Access Compliance Report

Public Rights-of-Way

(Curb Ramps)

Intersection ID: 12704	Main Street: E_5TH_ST	Cross Street: N_DAVIDSON_ST	Location: S
ADA ID: 6F9DFCDFDB3A	Ramp Type: PerpDiag	Initial Pass/Fail: Fail	Overall Compliance: No
		Severity Score: 37.5

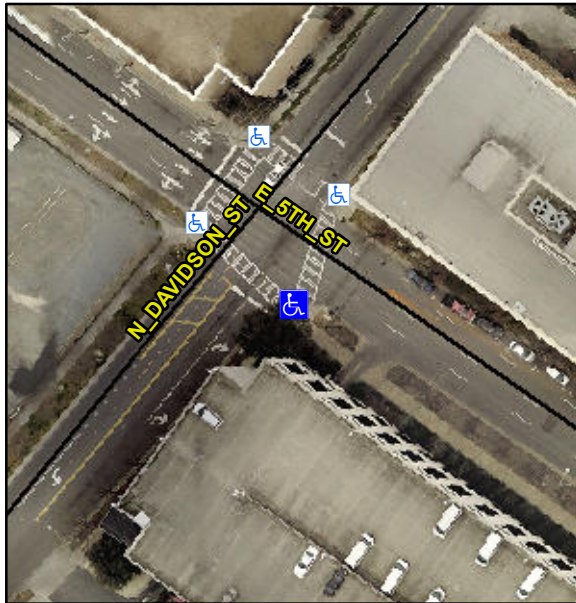
Not Found, R304.2.2, R304.5.3

Compliance	Description	Data	Compliance	Description	Data
N/A	Ramp Length (in)	37.0	No	Ramp Slope (%)	8.9
Yes	Ramp Width (in)	52.0	No	Ramp XSlope (%)	9.6
N/A	Flare Type LT	N/A	N/A	Flare Type RT	N/A
N/A	Flare Slope LT (%)	N/A	N/A	Flare Slope RT (%)	N/A
N/A	Flare Traversable LT?	N/A	N/A	Flare Traversable RT?	N/A
N/A	Landing Length (in)	N/A	N/A	DWS Provided?	N/A
N/A	Landing Width (in)	N/A	N/A	DWS Contrast?	N/A
N/A	Landing Slope (%)	N/A	N/A	DWS Length (in)	N/A
N/A	Landing X Slope (%)	N/A	N/A	DWS Full Width?	N/A
N/A	Landing Curb? (Y/N)	N/A	N/A	DWS Offset (in)	N/A
N/A	Shared Landing?	N/A			
N/A	Gutter Ponding?	N/A	N/A	Gutter Slope (%)	N/A
N/A	Gutter Lip Ht (in)	N/A	N/A	Gutter X Slope (%)	N/A
N/A	Painted X Walk1?	Yes	N/A	Painted X Walk2?	Yes
	X Walk 1 Direction	To NE		X Walk 2 Direction	To NW
N/A	X Walk 1 Width (in)	110.0	N/A	X Walk 2 Width (in)	99.0
	X Walk 1 Slope (%)	0.8		X Walk 2 Slope (%)	3.8
	X Walk 1 X Slope (%)	7.2		X Walk 2 X Slope (%)	6.0

Remove & Replace Curb Ramp With Two New Directional Ramps or Equivalent. Restripe Crosswalk.
